| Docket Number: | 24-BSTD-01 |
| Project Title: | 2025 Energy Code Rulemaking |
| Document Title: | 2025 Reference Appendices to the 2025 Building Energy Efficiency Standards, Express Terms, 15-Day Language |
| Description: | This document is the California Energy Commission's proposed changes for the 2025 Reference Appendices, Express Terms, 15-Day Language. |

~~Figure JA12-1 Sample JA12 Label~~

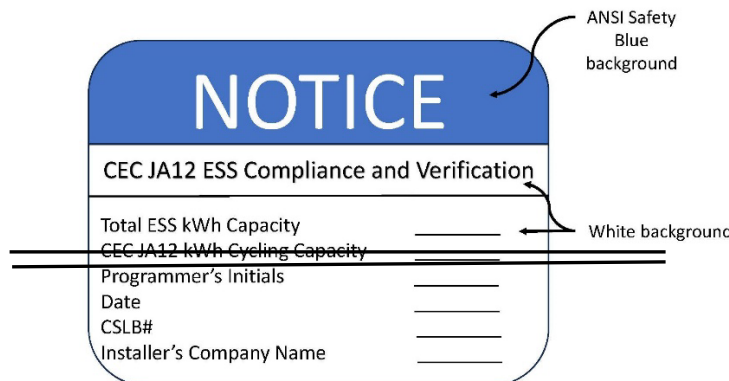
~~(a) JA12 compliance cycling capacity in kWh~~

~~(b) Total capacity in kWh~~
